STATE OF HAWAII
DEPARTMENT OF TRANSPORTATION
HIGHWAYS DIVISION

ROADWAY DETAILS

KAHEKILI HIGHWAY WIDENING
Likelike Hwy. to Vicinity of Haiku Road
F.A. PROJECT NO. NH-083-1(26)

QUADGUARD SYSTEM ATTENUATOR AT STA. 6+80

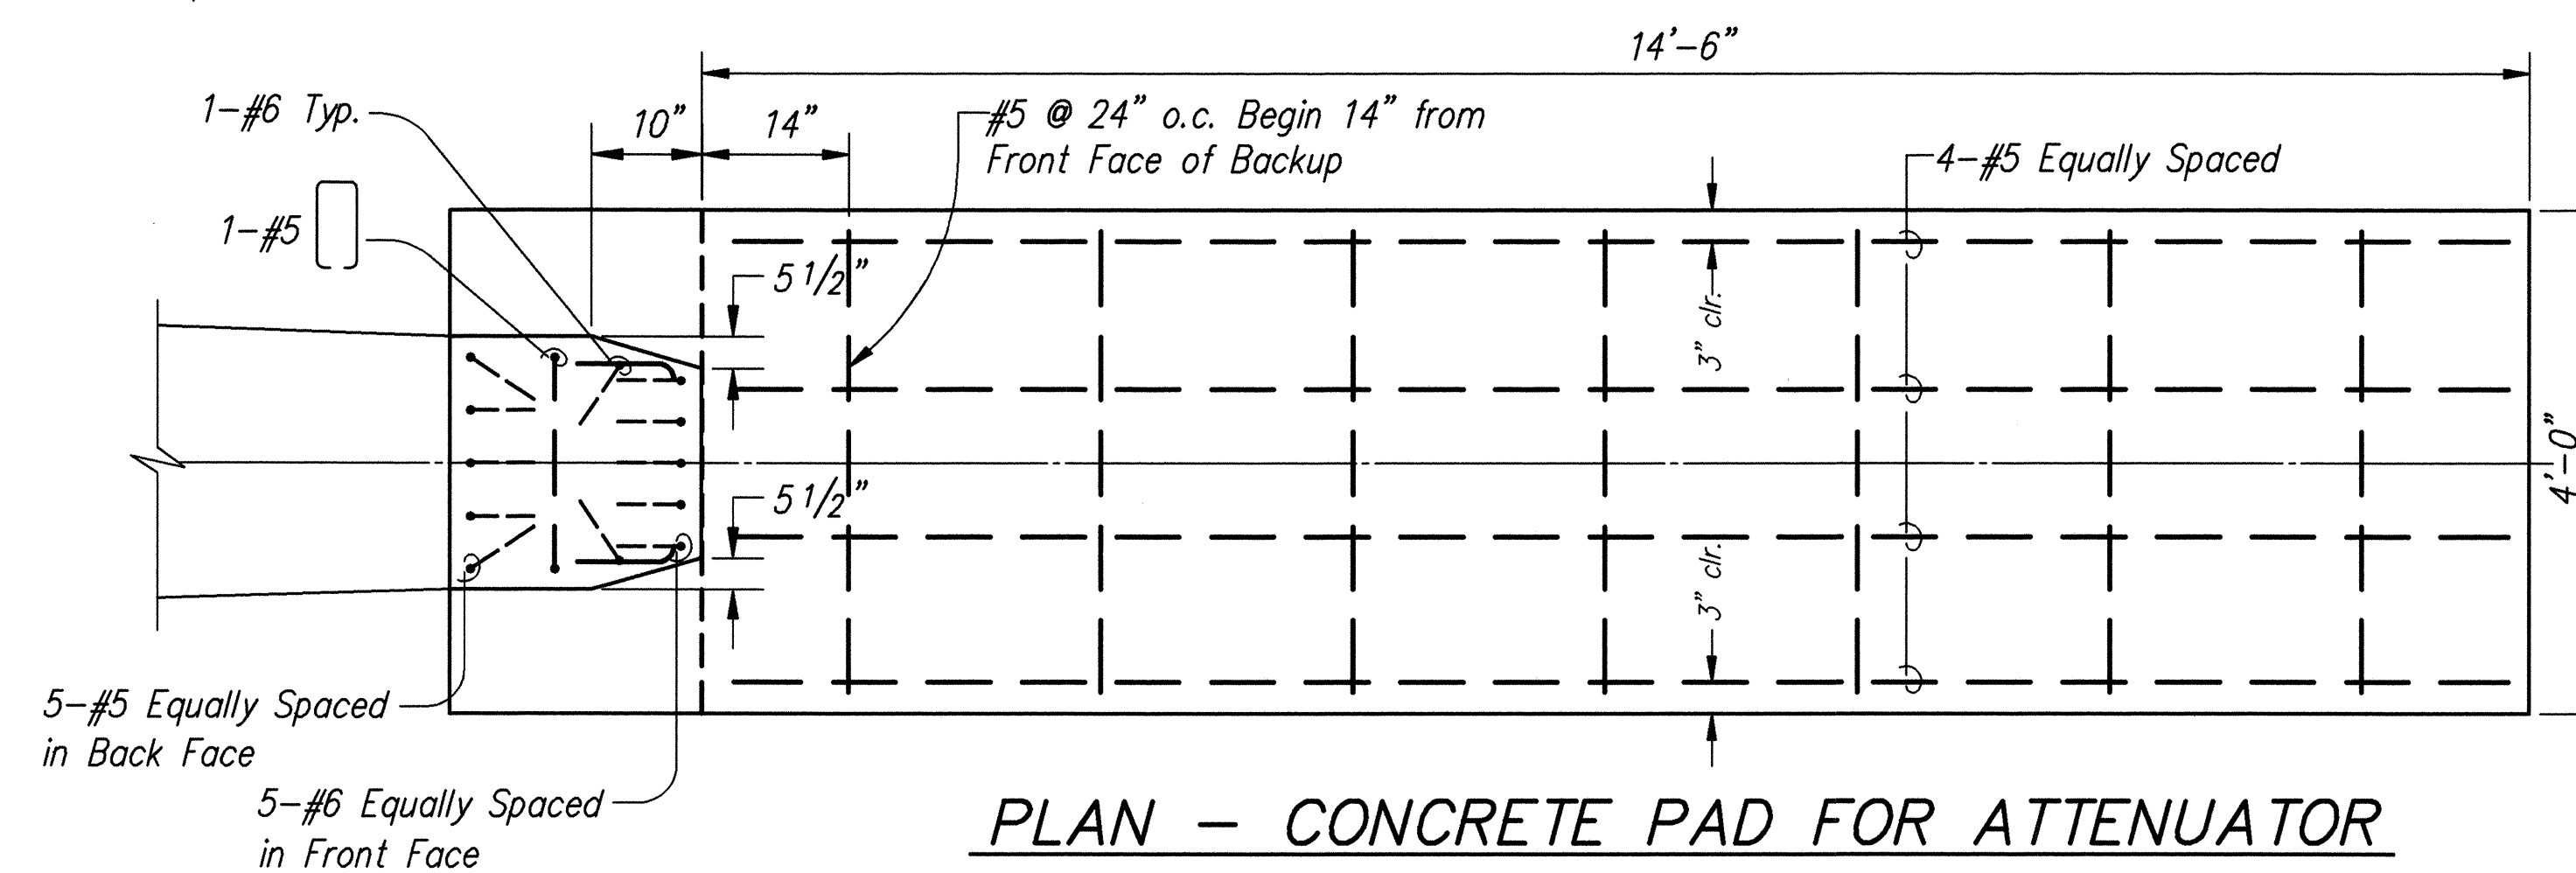
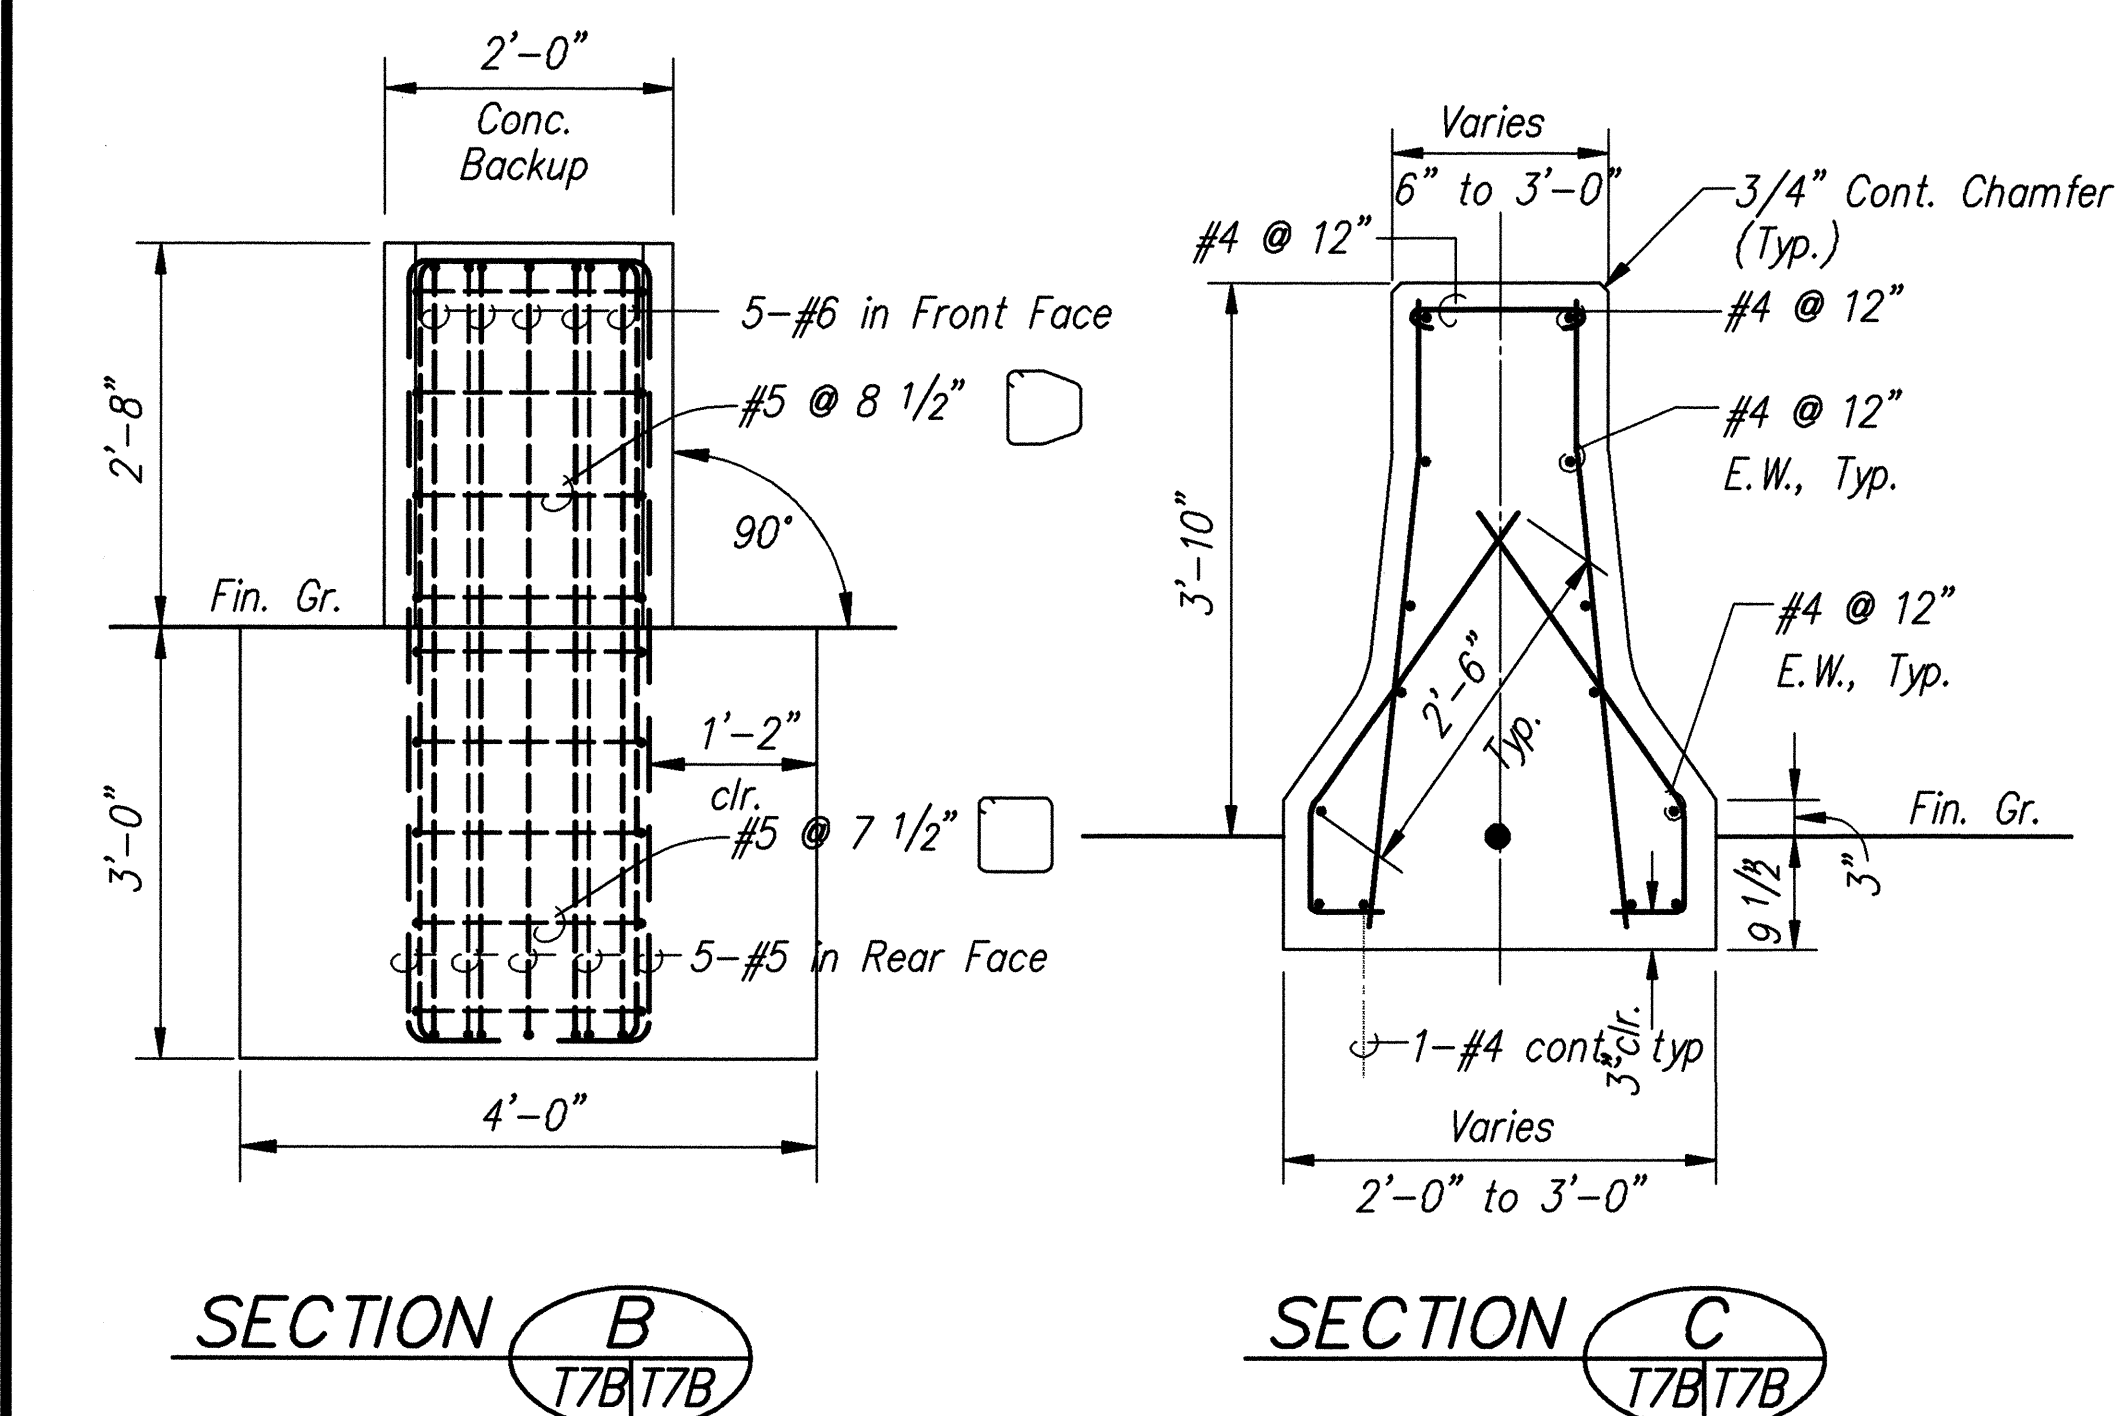
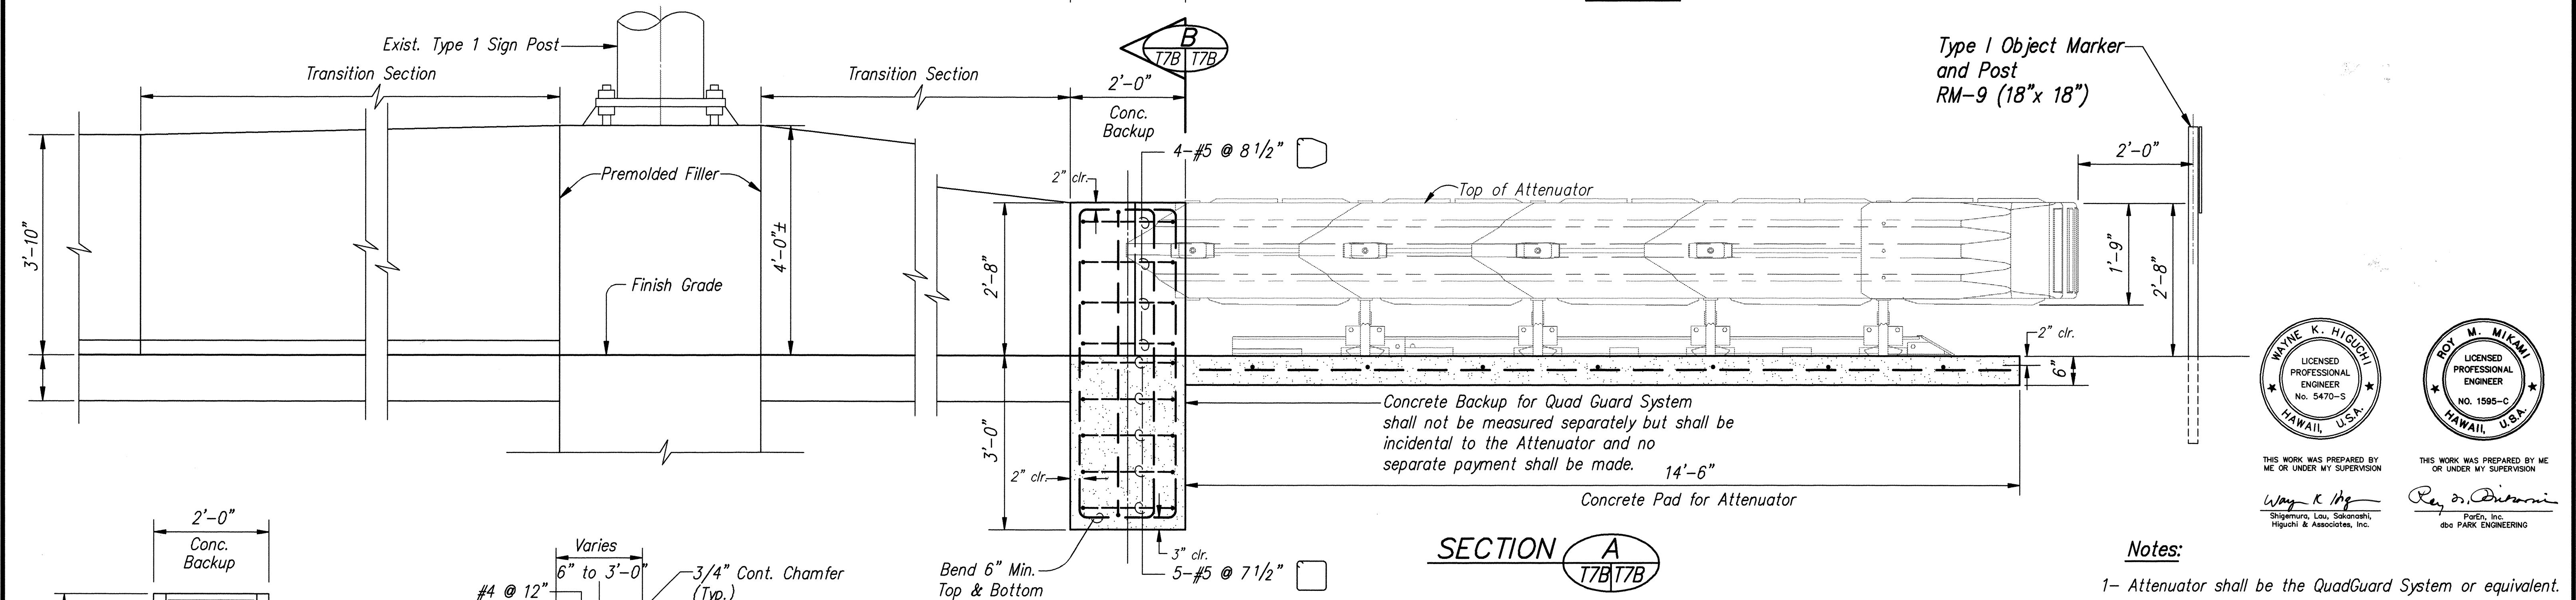
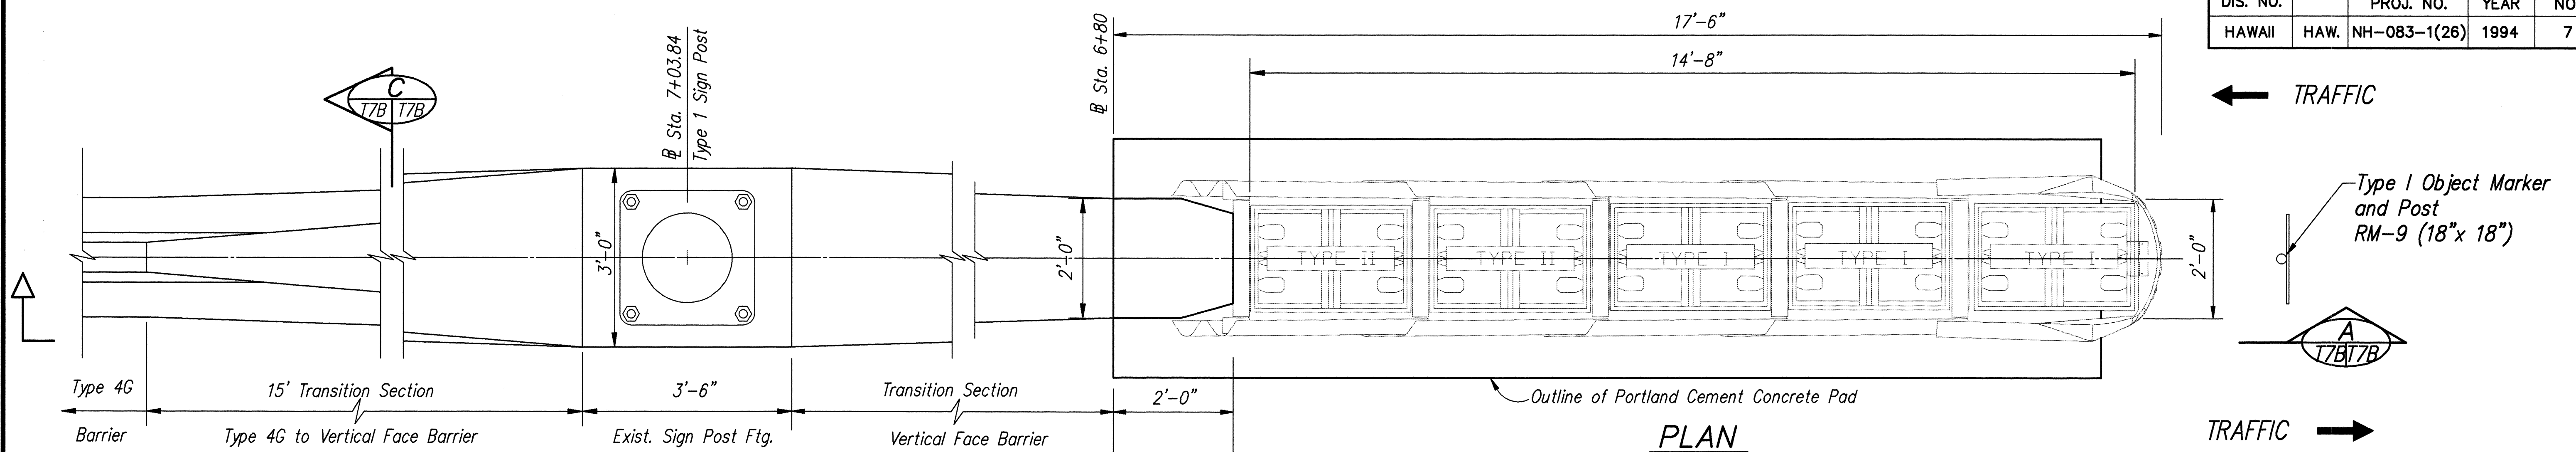
3/17/97	ADDED QUADGUARD ATTENUATOR AT STA 6+80
DATE	REVISION
